HISTORIC AND DESIGN REVIEW COMMISSION

HDRC CASE NO: 2025-096
ADDRESS: 331 CHANNING
LEGAL DESCRIPTION: NCB 3819 BLK 25 LOT 33 THRU 44
ZONING: R-6
CITY COUNCIL DIST.: 3
APPLICANT: Beth Wells/Bender Wells Clark Design
OWNER: Desiree Salmon/CITY OF SAN ANTONIO
TYPE OF WORK: New park construction
APPLICATION RECEIVED: April 09, 2025
60-DAY REVIEW: June 08, 2025
CASE MANAGER: Bryan Morales

The applicant is requesting a Certificate of Appropriateness for approval to construct a new park located at 331 Channing.

SHEET TITLE & NUMBER:
Site Reference Plan

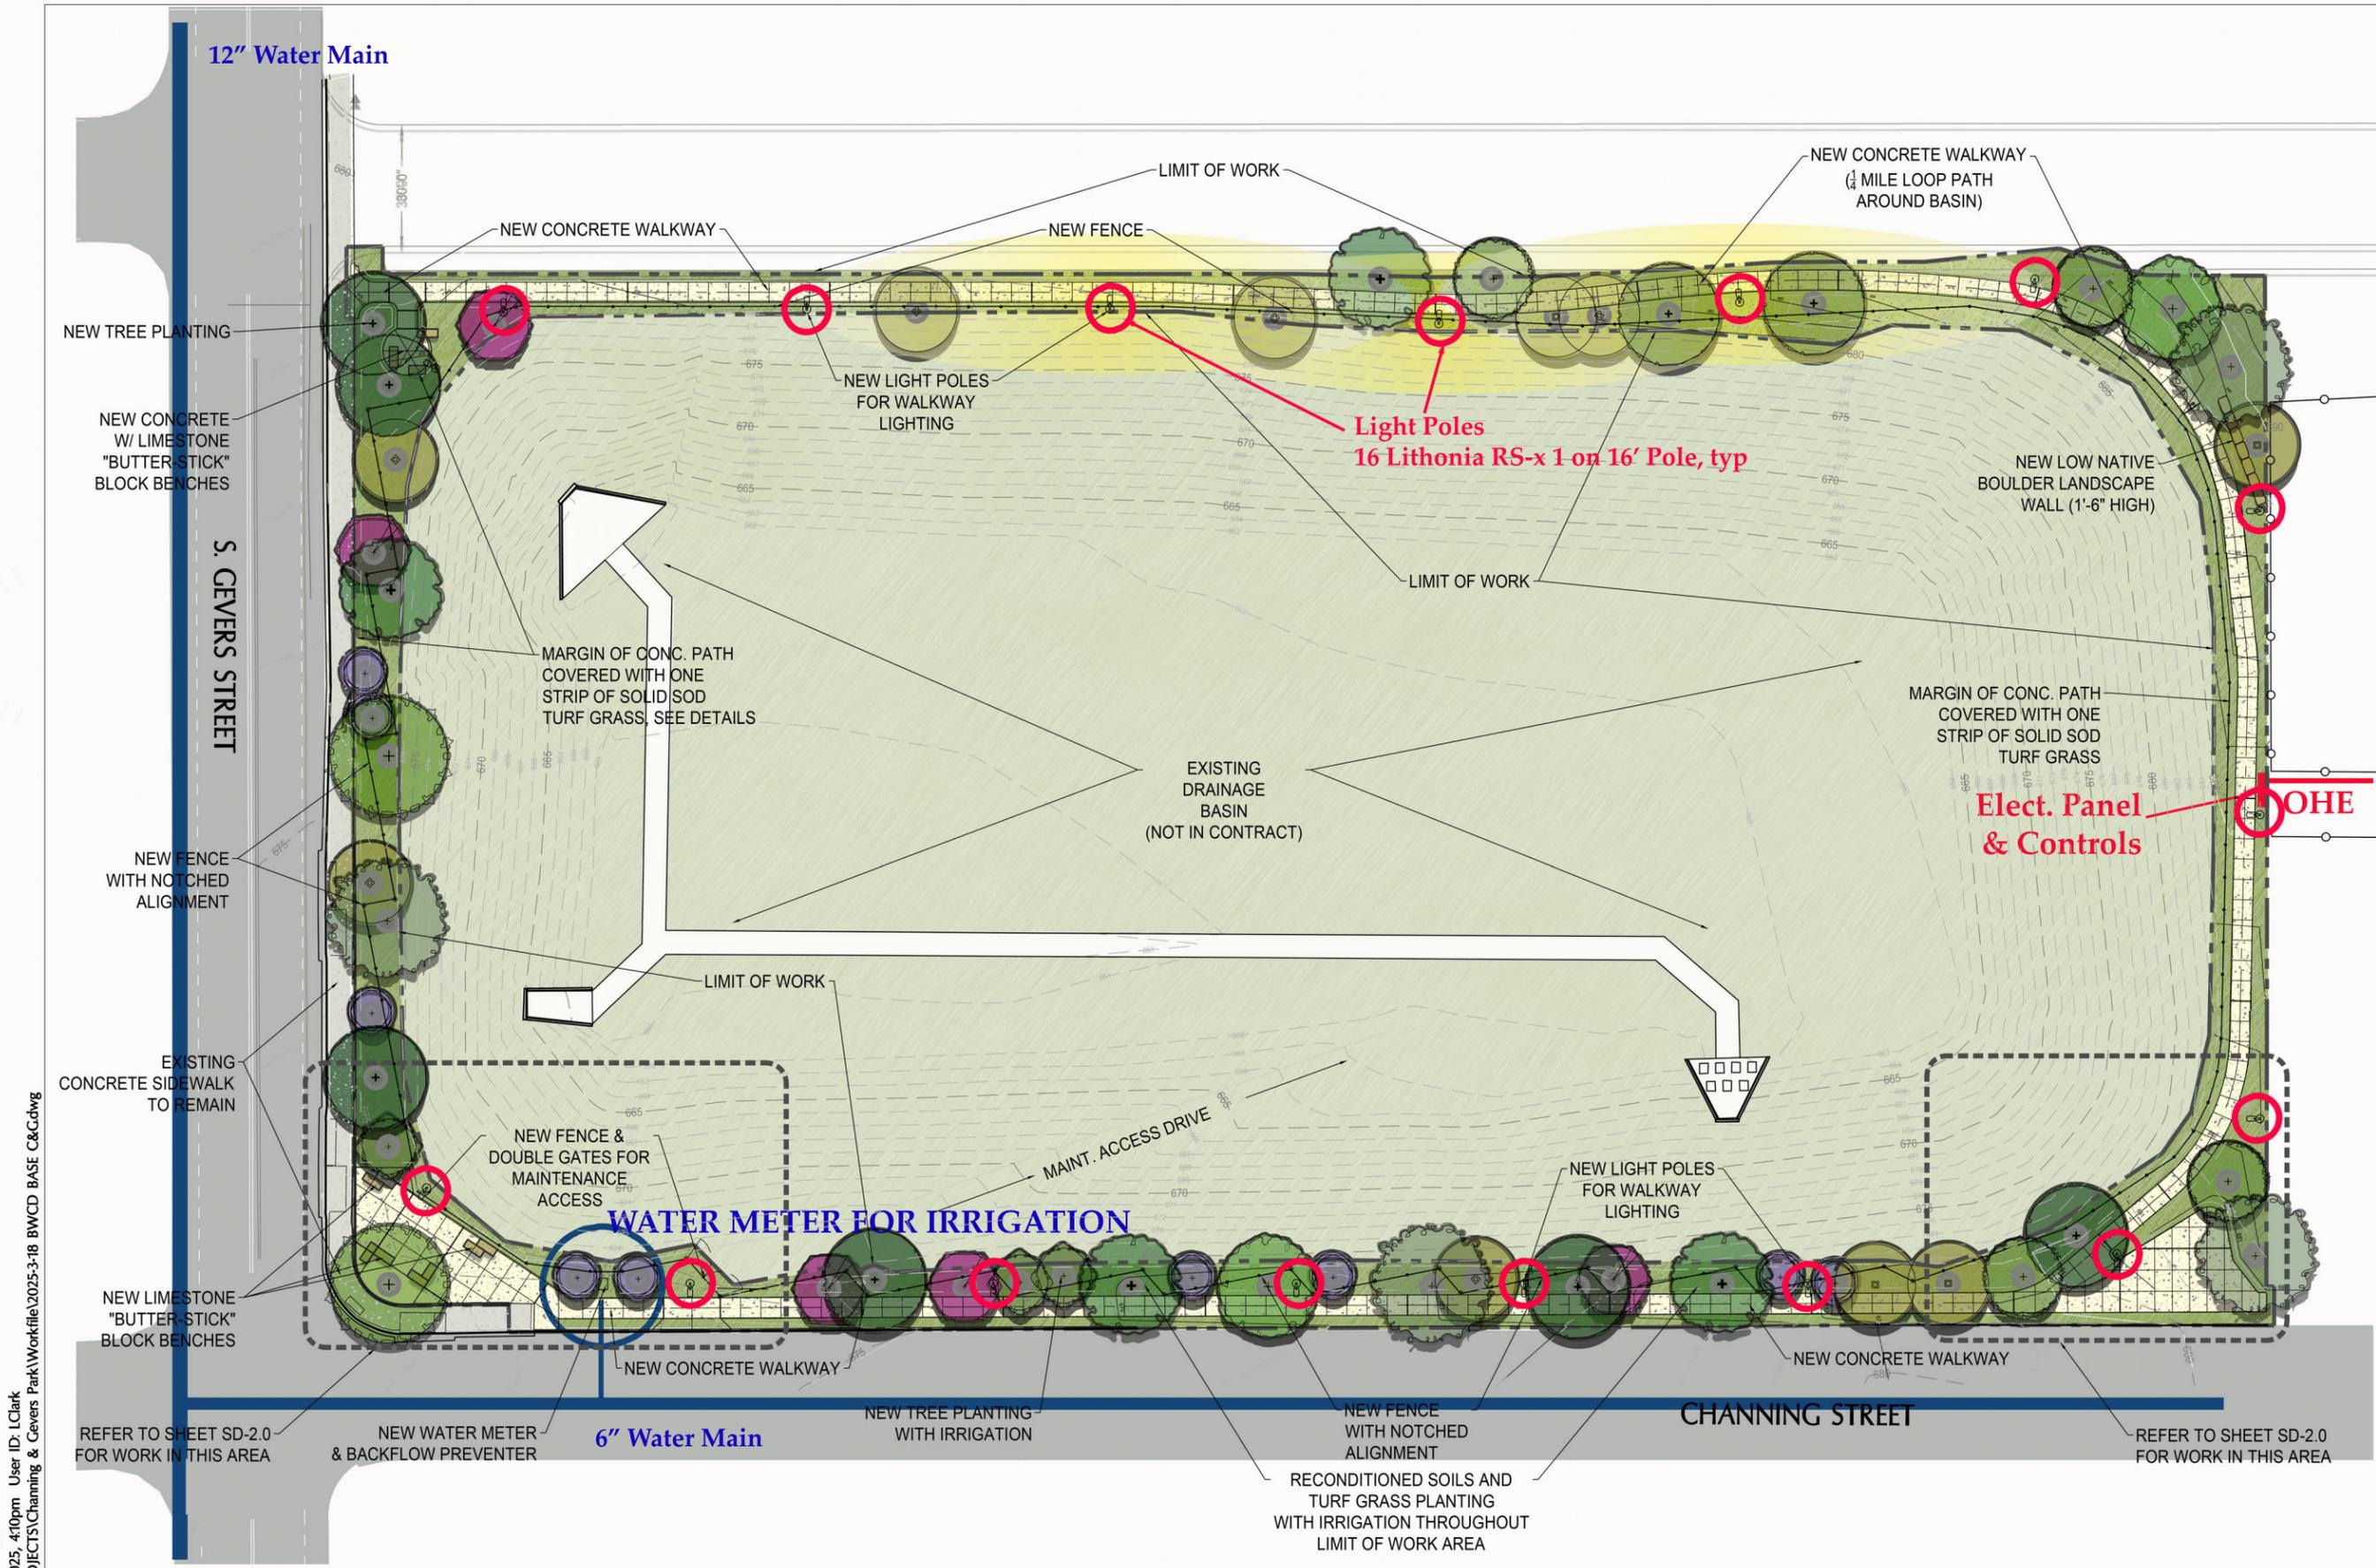
- a. The site currently proposed for the new Channing and Gevers Park is located east of S Gevers St, north of Channing, and west of S Mittman St. The new park will feature a new accessible concrete walk looping the existing drainage basin and connect to the existing sidewalk along Gevers St, new seating with large cut limestone blocks, decorative fencing to replace existing chain link fencing along the basin, new landscape elements, and new pedestrian lighting along the proposed concrete walkway.

- b. PARK AMENITIES – The applicant is requesting approval to construct a park with the following amenities: a walking concrete loop trail, new limestone block seating, wire mesh panel fencing, new lighting, and landscape modifications. Staff finds the proposal generally consistent with UDC Sec. 35-642.

- c. WALKWAYS – The applicant has proposed to install a walking concrete loop trail with lighting within the proposed park. UDC Sec. 35-642(b)(8) states that the site should take into account the compatibility of landscaping, parking facilities, utility and service areas, walkways and appurtenances. These should be designed with the overall environment in mind and should be in visual keeping with related buildings, structures and places. Staff finds the proposal generally consistent with the UDC Sec. 35-642.

- d. FENCING – The applicant has proposed to install wire mesh panel fencing to replace an existing chain link fence blocking access to the drainage basin. Staff finds the proposal generally consistent with the UDC.

Staff recommends approval of the proposal to develop Channing and Gevers Park as a new public park based on findings a through e with the following stipulation:

- i. ARCHAEOLOGY – The project shall comply with all federal, state, and local laws, rules, and regulations regarding archaeology, as applicable.
